**NORTHERN VIRGINIA STREAM RESTORATION BANK  
STATUS REPORT AND  
THE GLADE REACH 4A & 4B FINAL APPROVAL  
JUNE 16, 2009**

**Presented by Michael S. Rolband  
P.E., P.W.S., P.W.D.**

# REVISIONS TO PRELIMINARY PLAN REACH 4A

# REVISIONS TO PRELIMINARY PLAN REACH 4B

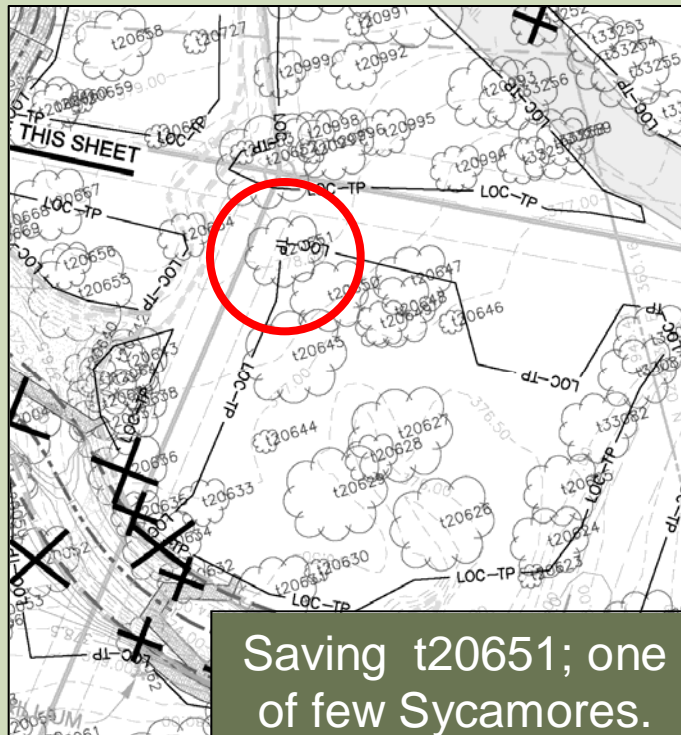
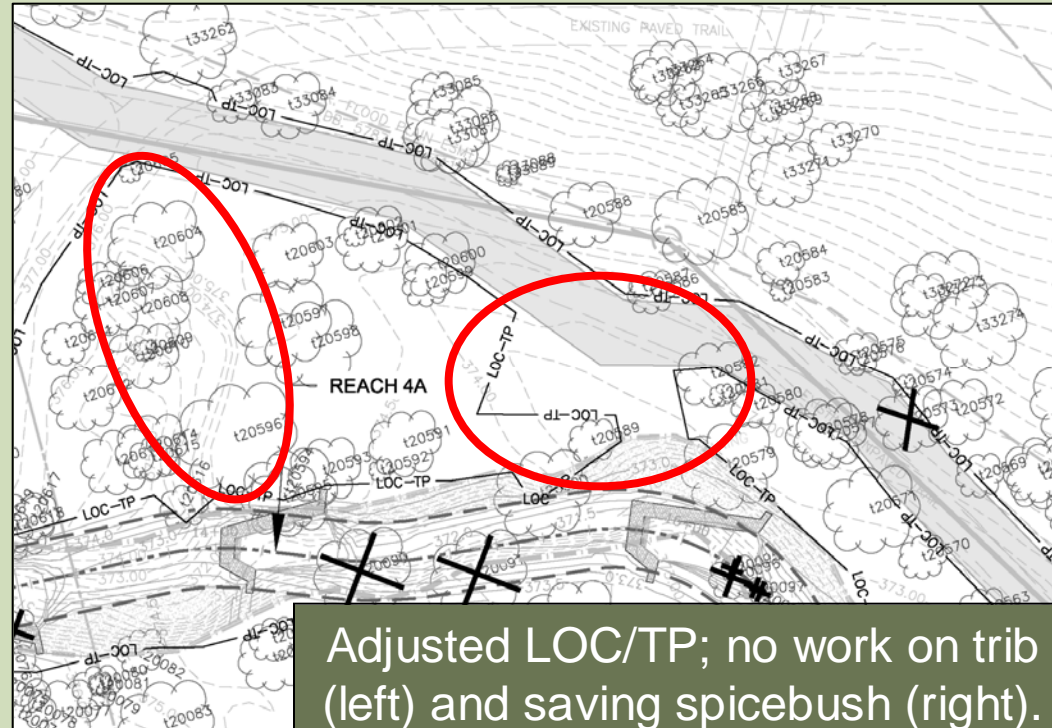
Minor LOC/TP revisions to avoid trees throughout.

Saving t20651; one of few Sycamores.

Adjusted LOC/TP; no work on trib (left) and saving spicebush (right).

# REVISIONS TO PRELIMINARY PLAN REACH 4A (CONT.)

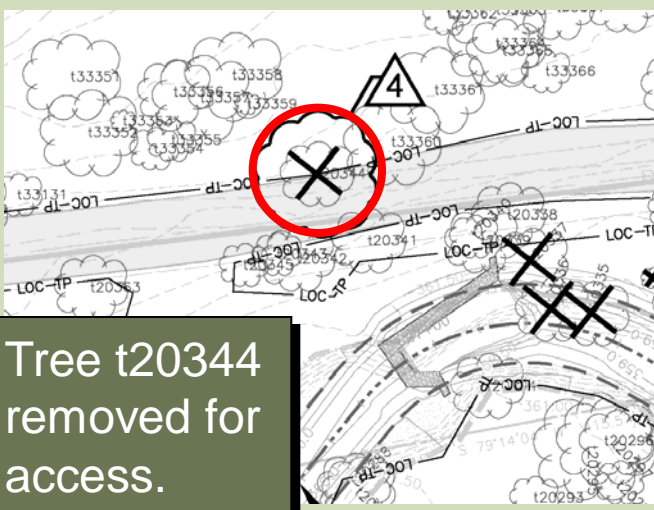
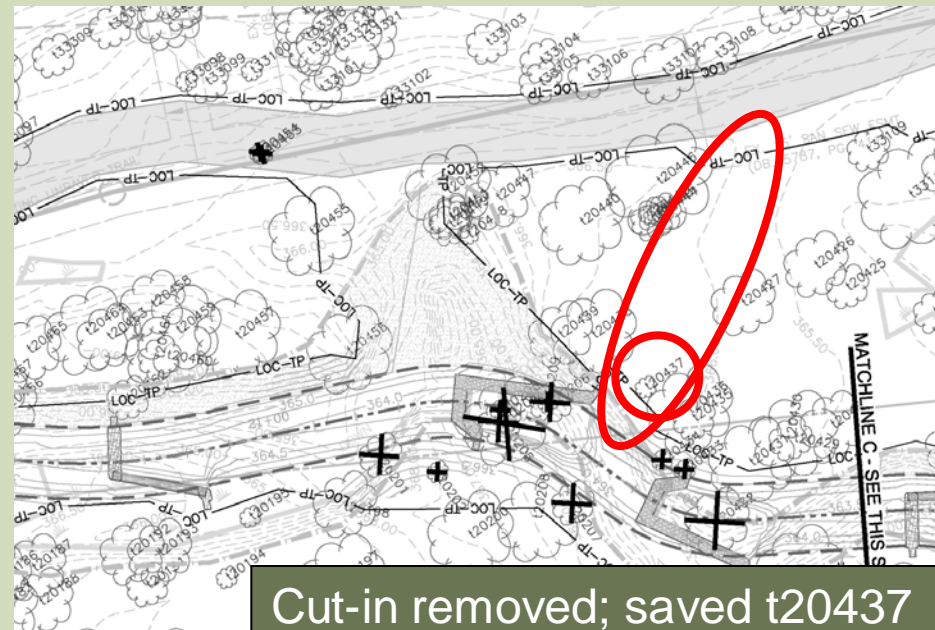
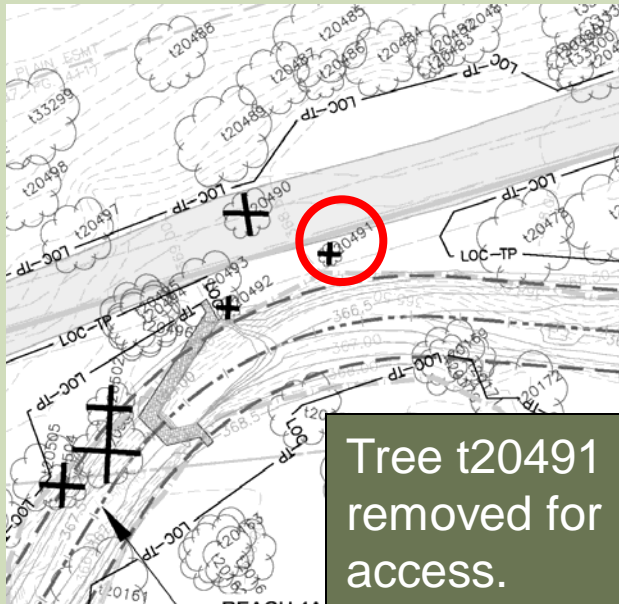
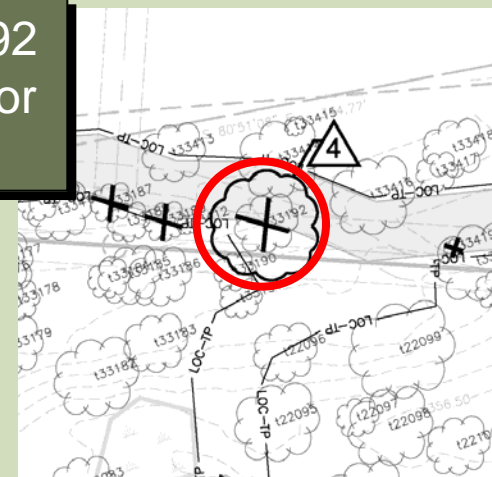
Tree t33192 removed for access.

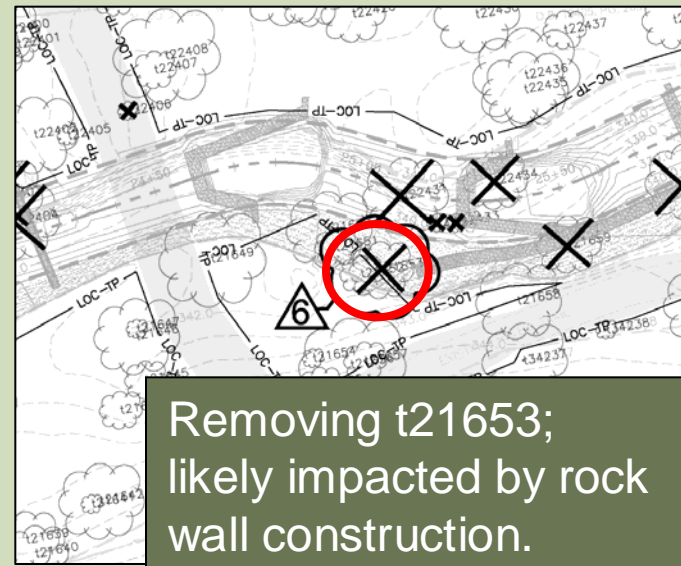
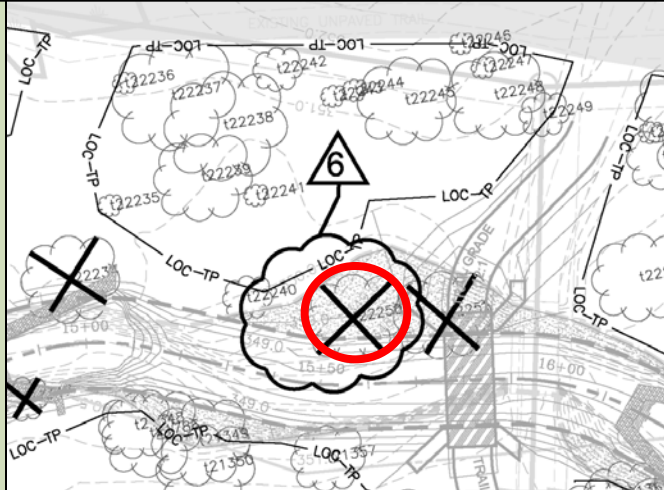
**Minor LOC/TP revisions to avoid trees throughout.**

## Removing t22250; uprooting.

Removing t21653;  
likely impacted by rock  
wall construction.

# REVISIONS TO PRELIMINARY PLAN REACH 4B (CONT.)

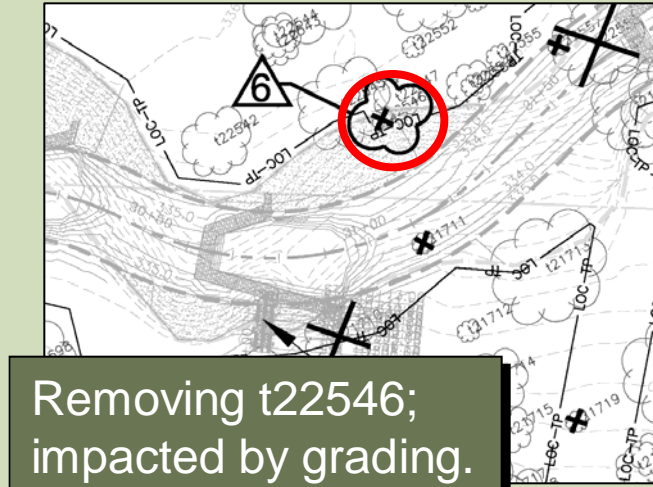
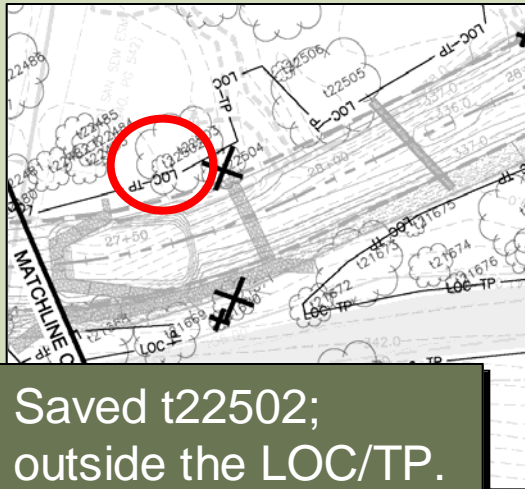
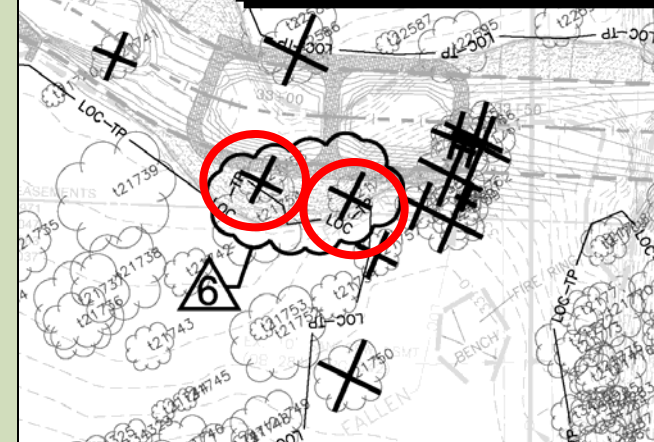
Removing t21755  
(left) which will  
most likely be  
impacted by rock  
step and & t21756  
(right) which has  
fallen.

### Clarke Hydrology Comparison Table – 100-yr Flows

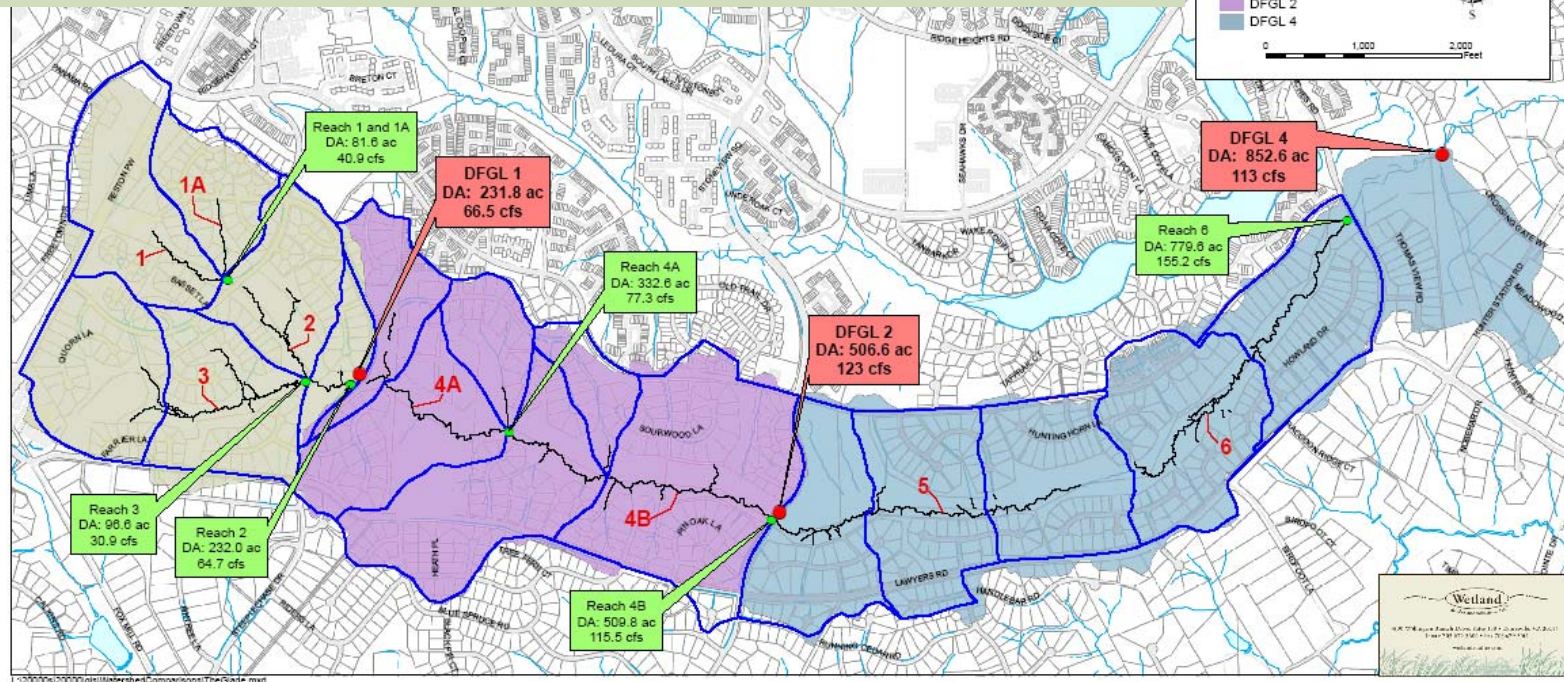
### Jon Clarke's Hydrology Concerns

- Jon Clarke obtained flow data from Fairfax County – Storm Water Management Model (SWMM) output used in development of the Difficult Run Watershed Management Plan
- Provided the following table and asked us to explain the differences

- Biggest reason for difference – incorrect correlation of watersheds between models
- DFGL 1 vs Glade 4 – Corrected: DFGL 1 vs Glade 2
- DFGL 2 vs Glade 5 – Corrected: DFGL 2 vs Glade 4
- DFGL 3 vs Glade 6 – Correctly correlated by Clarke

- Close agreement at outlet of Reaches 2 and 4
- Decrease in flow from Reach 4 to Reach 6 unlikely in “flashy” urban system.
- Difference for Reach 6 likely due to tendency of Storm Water Management Model (SWMM) to over attenuate (dampen) peak flows.
- Resolution of Data – Gross vs Detailed:
  - 5’ (Fairfax County) vs 0.5’ (WSSI) Contour Interval data
  - 3 (Fairfax County) vs 17 (WSSI) subwatersheds

- Close agreement between Fairfax County Board approved USGS model and WSSI flows
- SWMM model flows significantly less than both Fairfax County USGS approved floodplain data and WSSI predictions – SWMM results are not reasonable in this situation
- Reach 6 flow again shows over-attenuation – added effect possible from Twin Branches Road culvert
